CUMBERLAND DESIGN EXCELLENCE PANEL

MEETING MINUTES

PROPERTY ADDRESS	51 Rawson Street, Auburn
Application No.	PL 2020/0074
FILE No.	
PANEL MEMBERS	Mr Jon Johanson – Architect (Chair) Mr Aldo Raadik – Architect Mr Ian Armstrong – Architect
APOLOGIES	nil
ATTENDEES	
COUNCIL STAFF	
APPLICANTS	
DECLARATION OF INTEREST	Nil
REASONS FOR CONSIDERATION BY CDEP	Pre-Lodgement review by DEP and presentation of proposal by Architect
BACKGROUND/PREVIOUS MEETINGS/SITE MEETINGS	Nil

PROPERTY ADDRESS	51 Rawson Street, Auburn
Application No.	DA2021/0132
FILE No.	
PANEL MEMBERS	Mr Jon Johannsen – Architect (Chair) Mr Aldo Raadik – Architect Mr Ian Armstrong – Architect
APOLOGIES	nil
ATTENDEES	
COUNCIL STAFF	
APPLICANTS	
DECLARATION OF INTEREST	Nil
REASONS FOR CONSIDERATION BY CDEP	re - presentation of DA submission by Architect to DEP
BACKGROUND/PREVIOUS MEETINGS/SITE MEETINGS	refer Minutes of Prelodgement meeting PL 2020/0074

51 Ranson St. Auburn
CCDP mark-up. 2/10/21

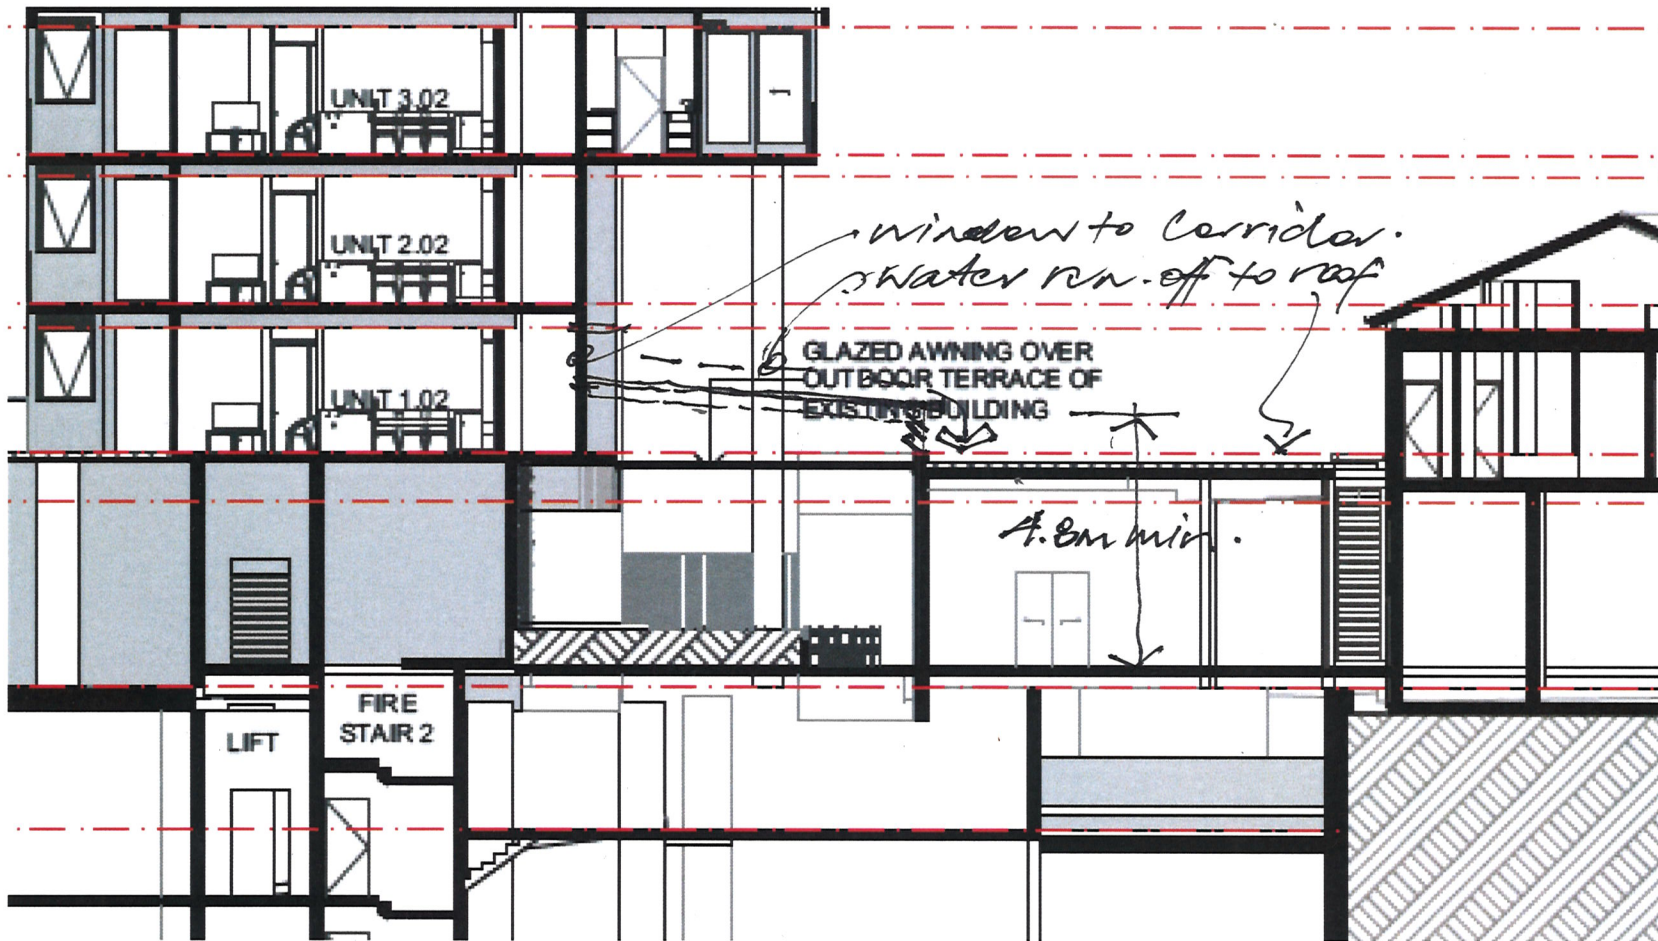
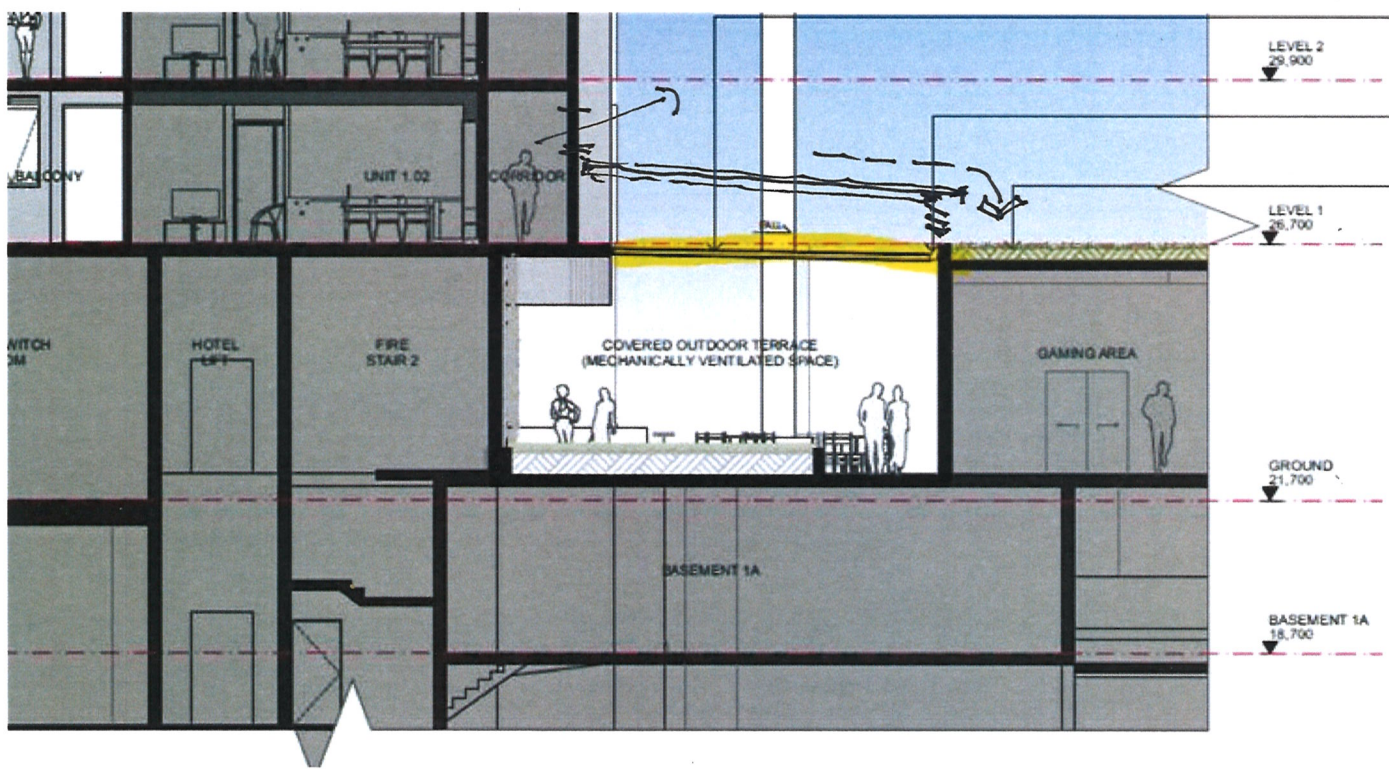
As per attached markup of Aldo's sketch below the glazed roof should be a min 4.8m and slope from under the sill of corridor windows down to the green roof, that will ensure there is good run-off for collected rainwater and scope for the introduction of some adjustable louvres in the vertical face.

All of this should enable a more comfortable space for this area and with scope for natural ventilation to complement a mechanical system, and without impacting on any privacy or visual impacts.
